# **VOLUME 8**

DEPARTMENT OF THE TREASURY  
BUREAU OF ALCOHOL, TOBACCO AND FIREARMS  
CORRESPONDENCE APPROVAL AND CLEARANCE

903050:RV  
3311/2005-372

903050:RDC  
3311/2005-561

**Figure 13 – Incremental Trigger, Disconnector & Trigger Bar Reset When Bolt Closed**

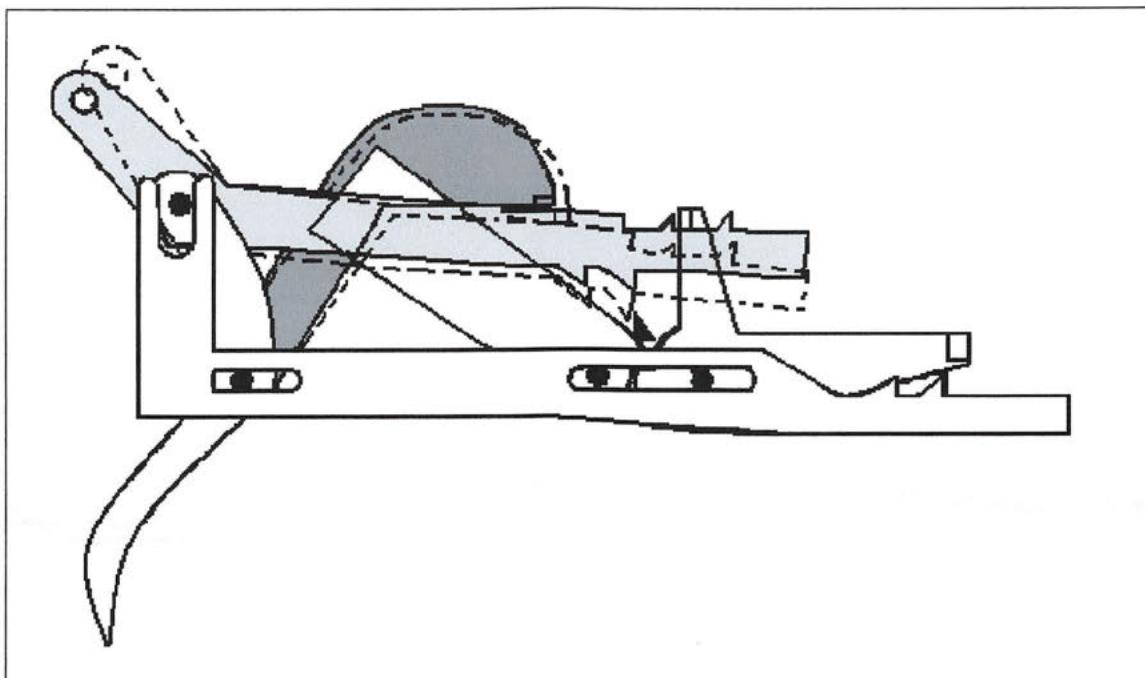
The FTB review of your correspondence found your final paragraph describing the incremental trigger assembly presented in Figure 13 somewhat unclear. You state that Figure 13 "shows the disconnector moving back up as the bolt moves to the closed position in much the same way as a generic trigger works. The trigger bar also moves up, being released from the trigger stop and a notch engages the sear and the trigger is once again ready to discharge the firearm by pulling the trigger farther backward, or the trigger can be released to totally reset the trigger mechanism allowing it to return to its original position." This description appears to indicate that the firearm would fire in stages and as such would not be a machinegun.

Our Branch cannot render a final disposition regarding your trigger device based solely on your written description. Further, we cannot authorize you to make a machinegun. However, you may submit a prototype to FTB for assembly into a firearm and for further evaluation with respect to its classification under Federal statutes.
